APPLICATION NO.	FILING DATE	FIRST NAMED INVENTOR	ATTORNEY DOCKET NO.	CONFIRMATION NO.
10/711,144	08/27/2004	Douglas D. Coolbaugh	BUR920040107US1	5143

Office Action Summary	Application No. 10/711,144	Applicant(s) COOLBAUGH ET AL.	
	Examiner Khiem D. Nguyen	Art Unit 2823

DETAILED ACTION

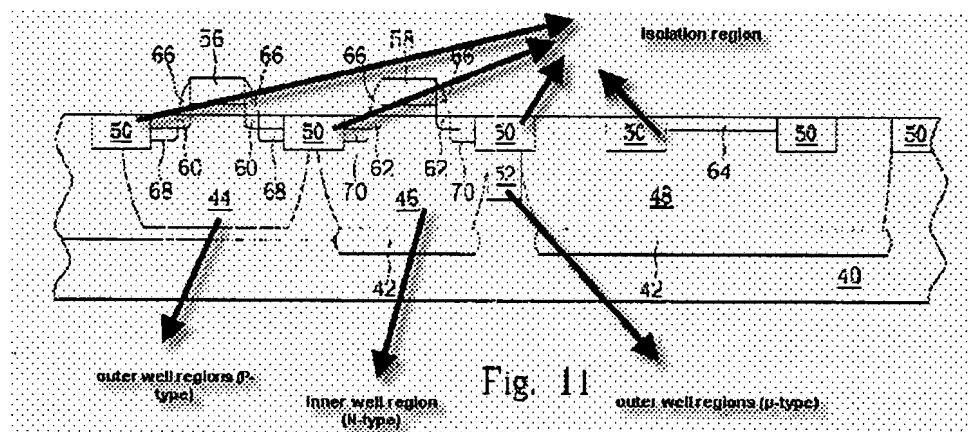
Applicants contend that the reference Gau (U.S. Patent 6,949,440), herein known as Gau, fails to disclose, inter alia, "a well region located in the upper region of the substrate, wherein the well region includes outer well regions of the second conductivity type and an inner well region of the first conductivity type, each well of alternating conductivity type of the well region is separated at an upper surface by an isolation region and each outer well region has an upper surface which includes a source/drain regions".

In response to Applicants' contention that Gau does not teach or suggest a well region located in the upper region of the substrate, wherein the well region includes outer well regions of the second conductivity type and an inner well region of the first conductivity type, each well of alternating conductivity type of the well region is separated at an upper surface by an isolation region, Examiner respectfully disagrees.

Applicants' attention is respectfully directed to (col. 4, lines 11-65 and FIGS. 8-10, for example) where Gau discloses a varactor structure comprising: a well region

located in the upper region of the substrate 40, wherein the well includes outer well regions 44 and 52 of the second conductivity type (P-type) (see col. 4, lines 27-40) and an inner well region 46 of the first conductivity type (N-type) (col. 4, lines 41-42), each well of alternating conductivity type (P-N-P) of the well region is separated at an upper surface by an isolation region 50 (see col. 4, lines 31-40 and FIG. 11, as shown below, for example).

For this reason, Examiner holds the rejection proper.
